CLEVE HILL SOLAR PARK

STATEMENT OF COMMON GROUND BETWEEN THE APPLICANT AND LOWER MEDWAY INTERNAL DRAINAGE BOARD

August 2019
Revision A

Document Reference: 12.2.5
Submitted: Deadline 4

Produced By: LN	Ref: 2238-PUB-088
Checked By: MB	Date: 23/06/2019

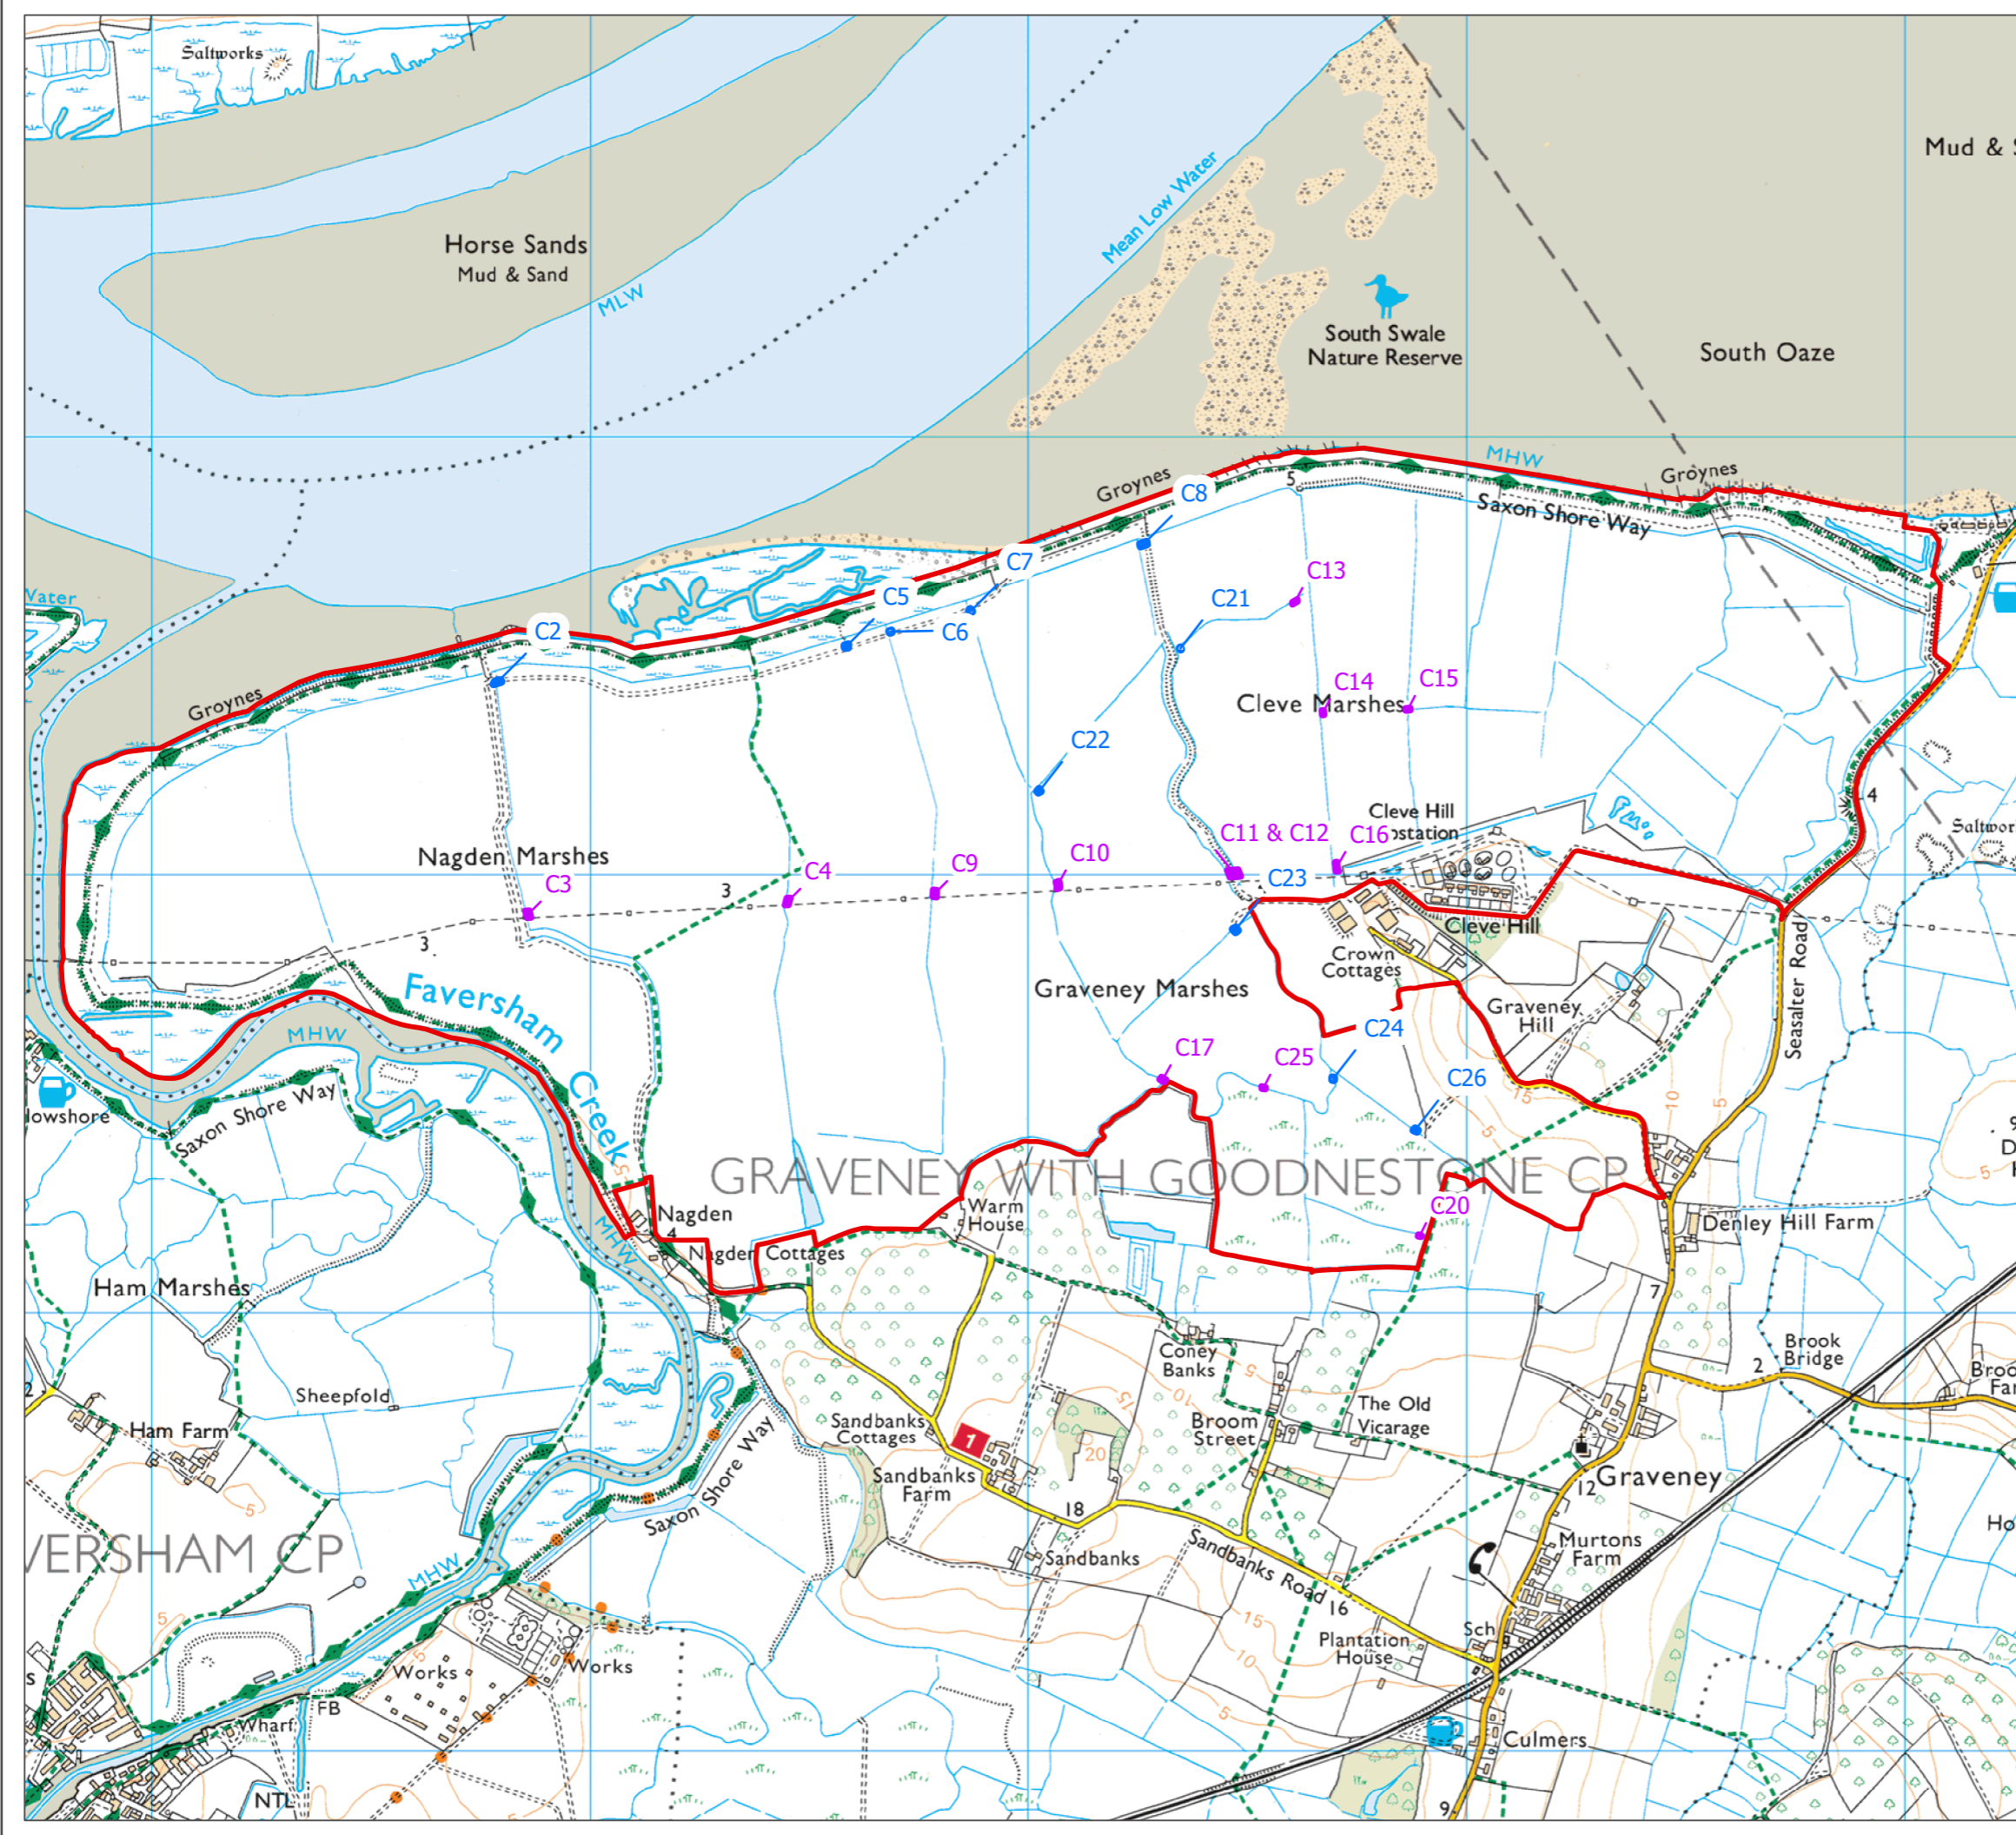
<p><u>Watercourse Crossings (New and Upgraded Culverts)</u></p> <p>All new and upgraded watercourse crossings for the spine road, field accesses, and perimeter fence crossings identified within the latest version of the Outline Construction and Environmental Management Plan (CEMP) [REP3-006] and shown on Figure 2238-PUB-088 of Appendix A of this SoCG will require Land Drainage Consent from the LM IDB or will require Ordinary Watercourse consent from the Lead Local Flood Authority (Kent County Council). The relevant consent will be applied for alongside the discharge of Requirements 2 (h), 8 and 10 of the dDCO [REP3-003].</p> <p>The latest version of the Outline CEMP [REP3-006] and Outline LBMP [REP3-005] specifies mammal and eel friendly box culverts to be used. The design of the crossings will be confirmed during the detailed design phase, in consultation with the LM IDB and the Lead Local Flood Authority.</p>	<p>IDB Consent will be required for any new structure.</p> <p>Consent will not be given in advance since at this stage the type of culvert and their exact location and application form + fee have yet to be submitted. Please allow a maximum of 2 months for consultation process.</p>

Produced By: LN Ref: 2238-PUB-093

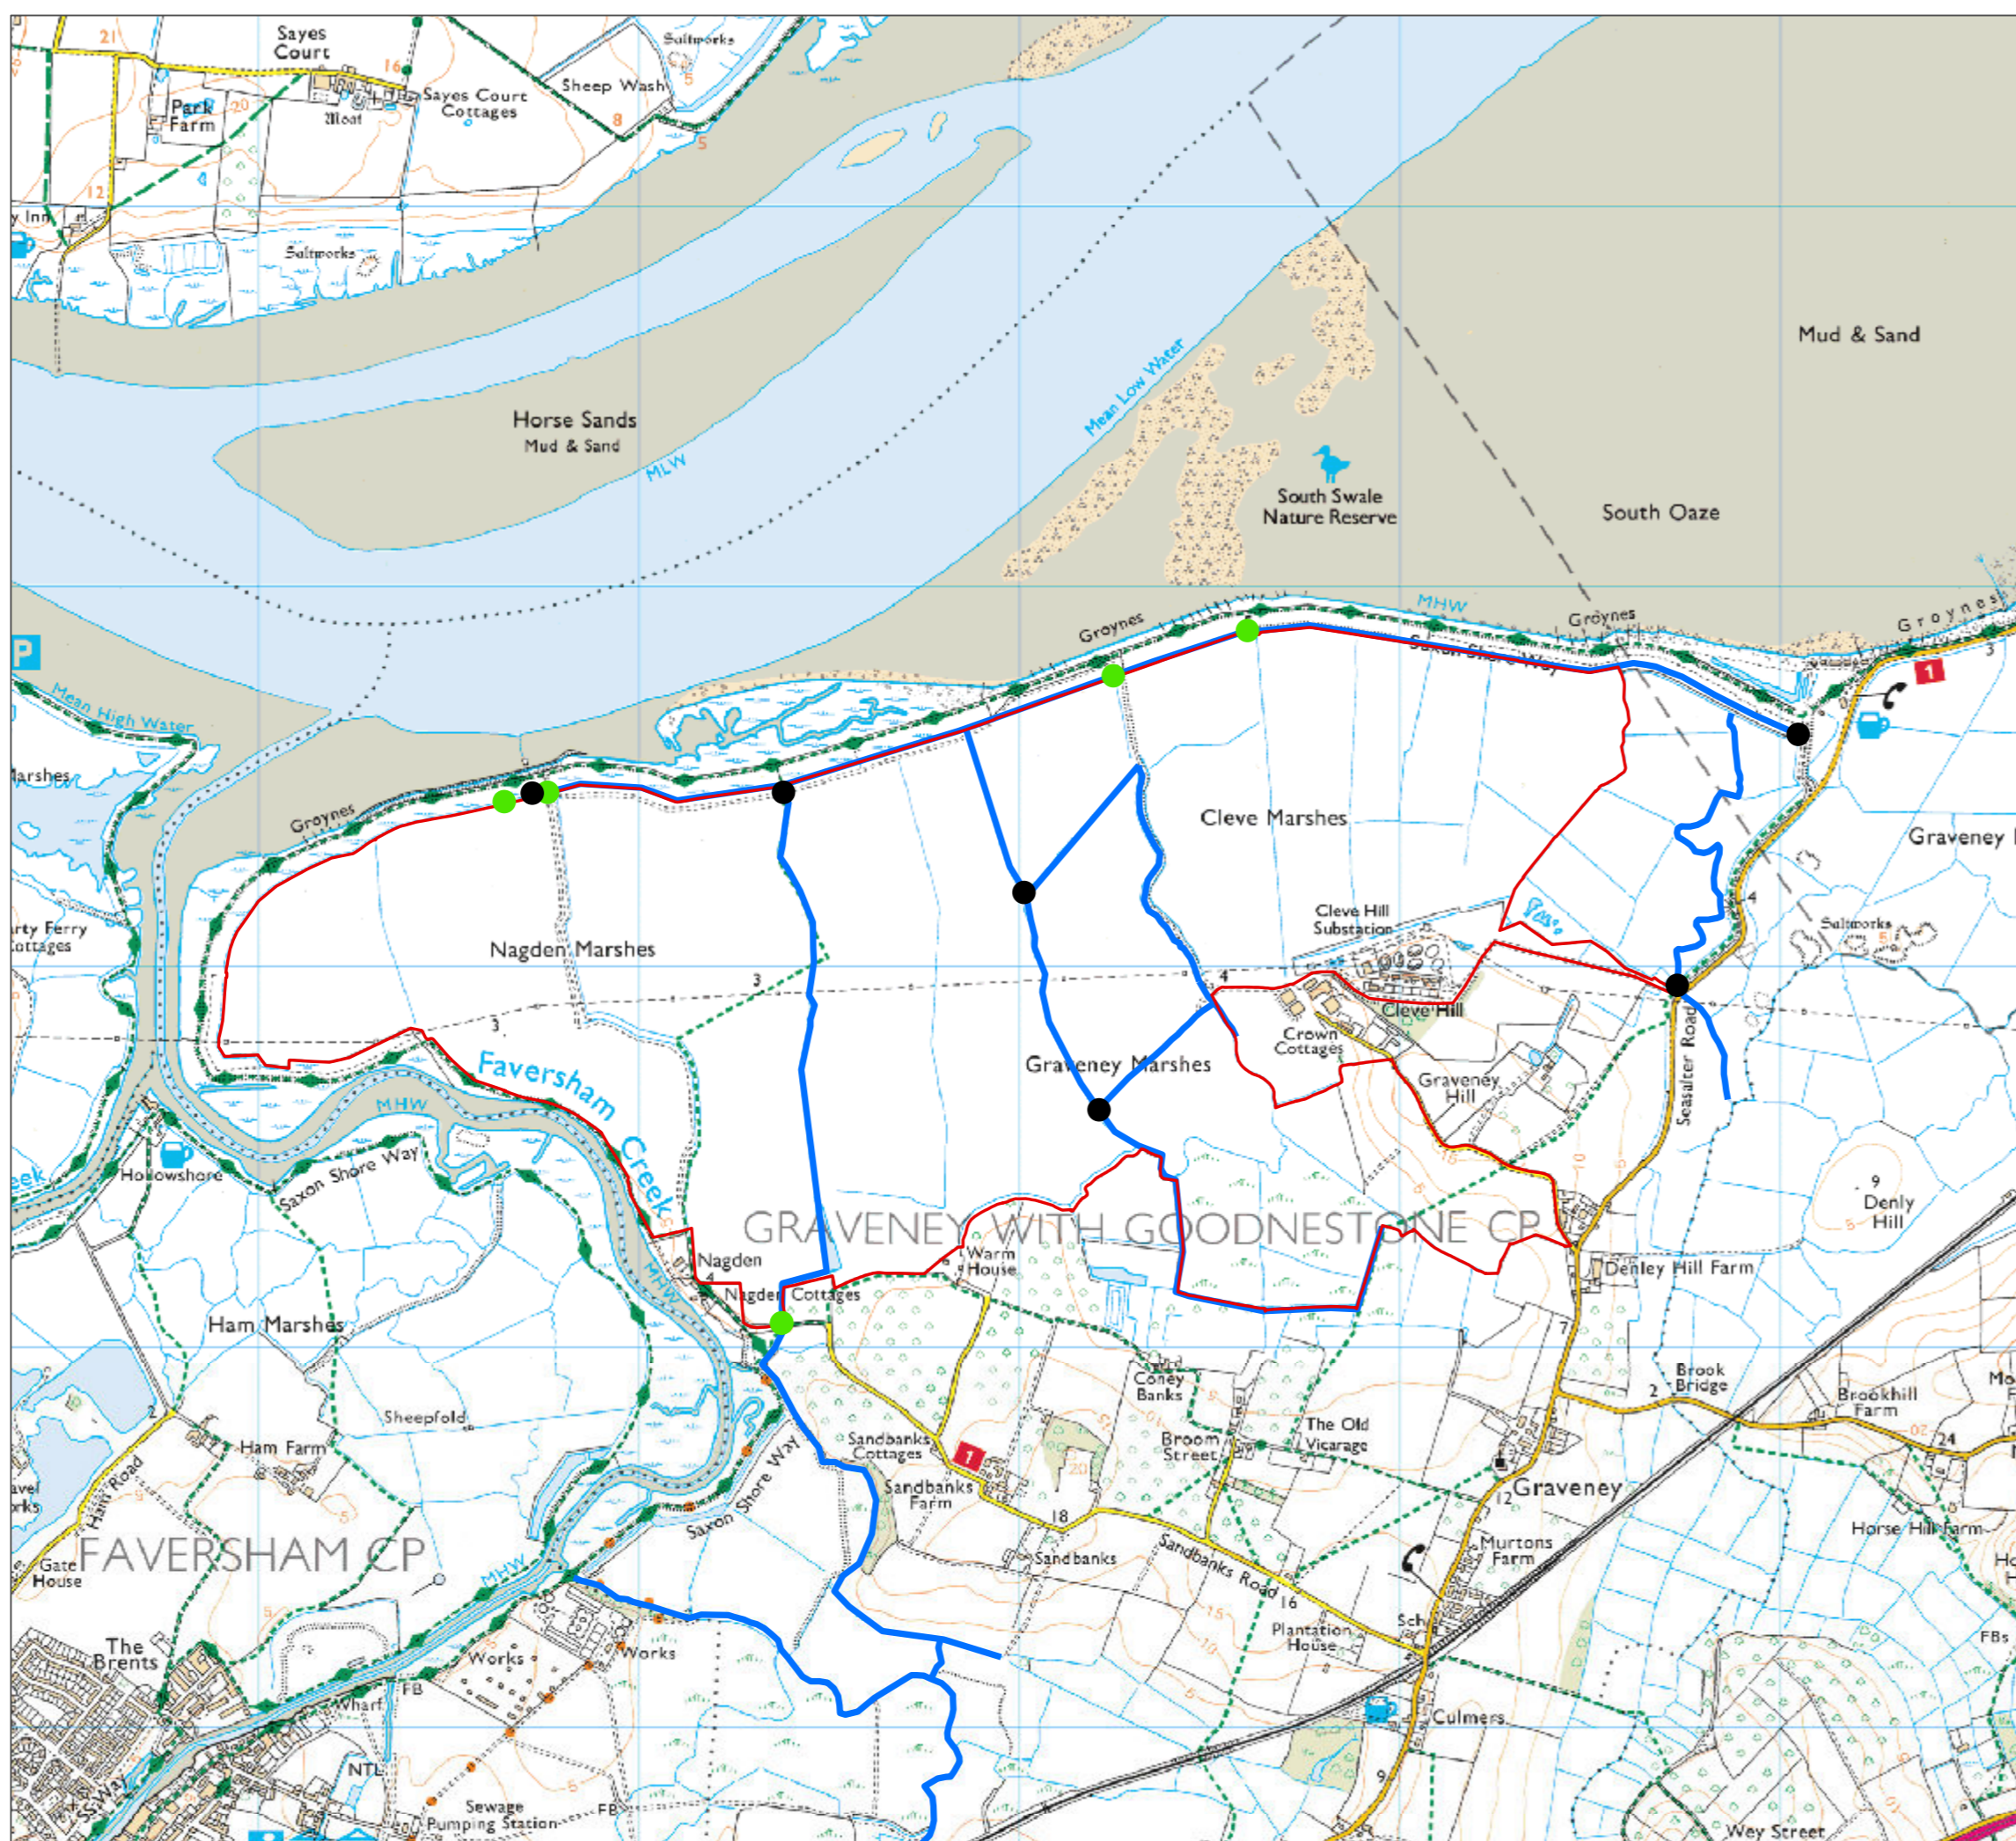
Rule 6 Letter SoCG Request	Applicant's Response	Status (LM IDB to complete)
	<p>Appendix A of this SoCG shows the key existing and proposed flow control structures which will be used to achieve this aim.</p> <p>Water may be either held back behind the structure, or sluice boards used as a top height, above which water may 'overtop' in a controlled fashion to maintain the water level at known height. An example of the implementation of drop board sluices for arable reversion is provided as Technical case study No. 5: Berney Marshes, Norfolk of RSPBs 'Water management structures for conservation - Technical case study series' [REP3-047].</p> <p>As such, the Applicant seeks agreement from the LM IDB that existing flow control infrastructure can be used to achieve this aim and that IDB Land Drainage Consent will be required for all new structures under Land Drainage Act 1991 as the IDB need to ensure the new structures do not impact upstream landowners. There will be an ongoing need to engage with all parties to deliver this.</p>
